RE: The Preserve Draft Environmental Impact Report (SCH #2019100515)

Civic Thread has reviewed the Draft Environmental Impact Report for The Preserve (SCH #2019100515) and we offer the following comments.

Figure 3. Parcel M connector path.

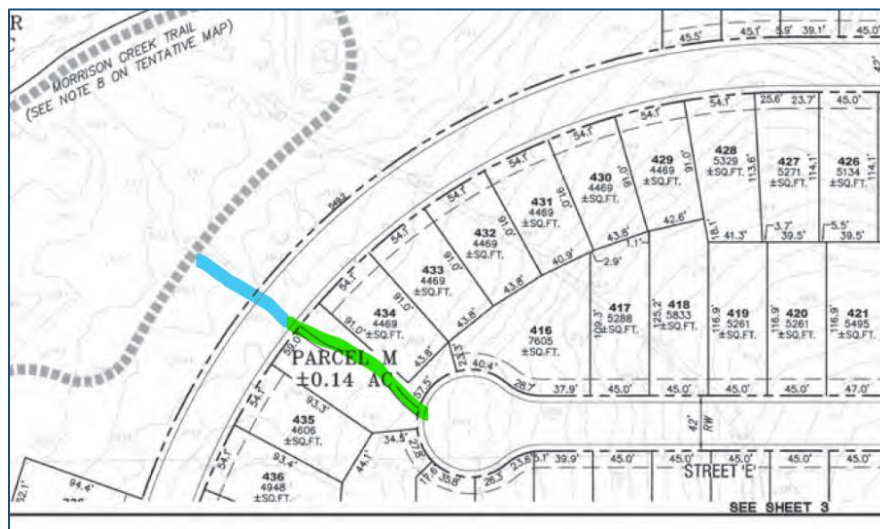
3. **Parcel M:** We are glad to see that a sidewalk goes through Parcel M to the street. We recommend including a path on the other side of the street that connects to the Morrison Creek Trail and a marked pedestrian crossing that connects the two pathways. Bike ramps should be included at each curb (see Figure 3).

Figure 4. Parcel D proposed connector path.

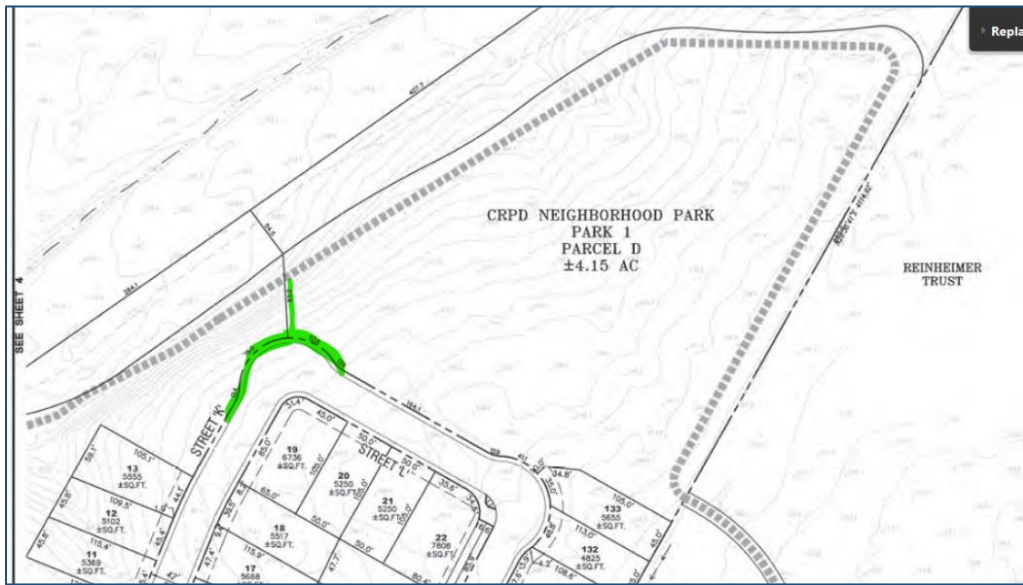
4. **Parcel D:** Include a pedestrian/bicycle connector path to the Morrison Creek Trail at CRPD Neighborhood Park 1 at the closest point at the intersection of Street 'K' and Street 'L' with a bike ramp at the curb (see Figure 4).

Figure 5. Parcel J proposed connector path.

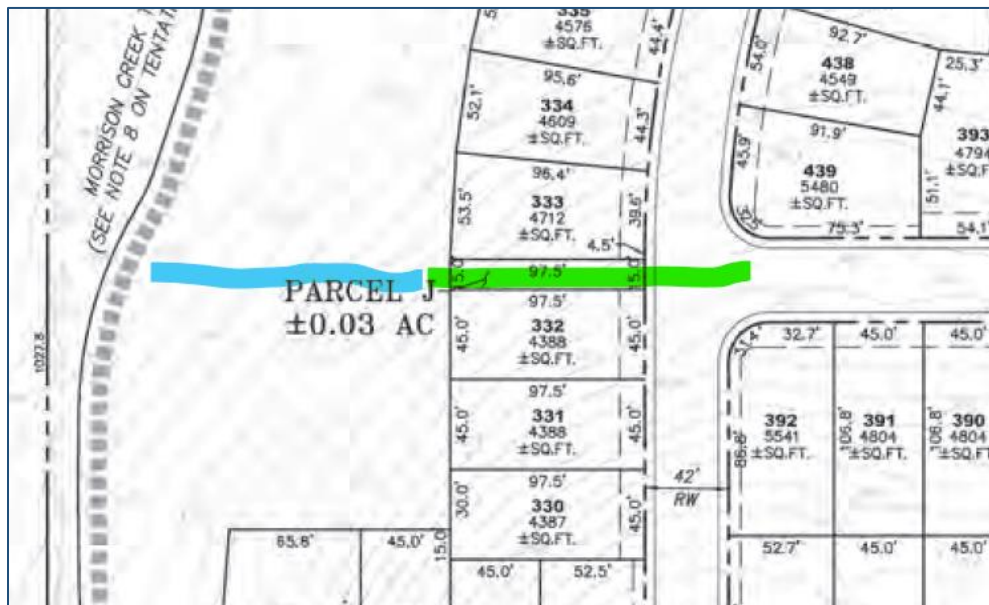
5. **Parcel J:** Per our letter submitted in July 2019, if Parcel J at the west end of Street 'D' is part of a neighborhood bicycle travel way, widen the parcel to at least 25' and construct a 10'-wide sidewalk that's bifurcated at the eastern terminus and includes bike ramps at the curb. Parcel J is a logical entry point to access the Morrison Creek Trail but needs to be widened to allow for a sidewalk and landscaping on both sides (see Figure 5).
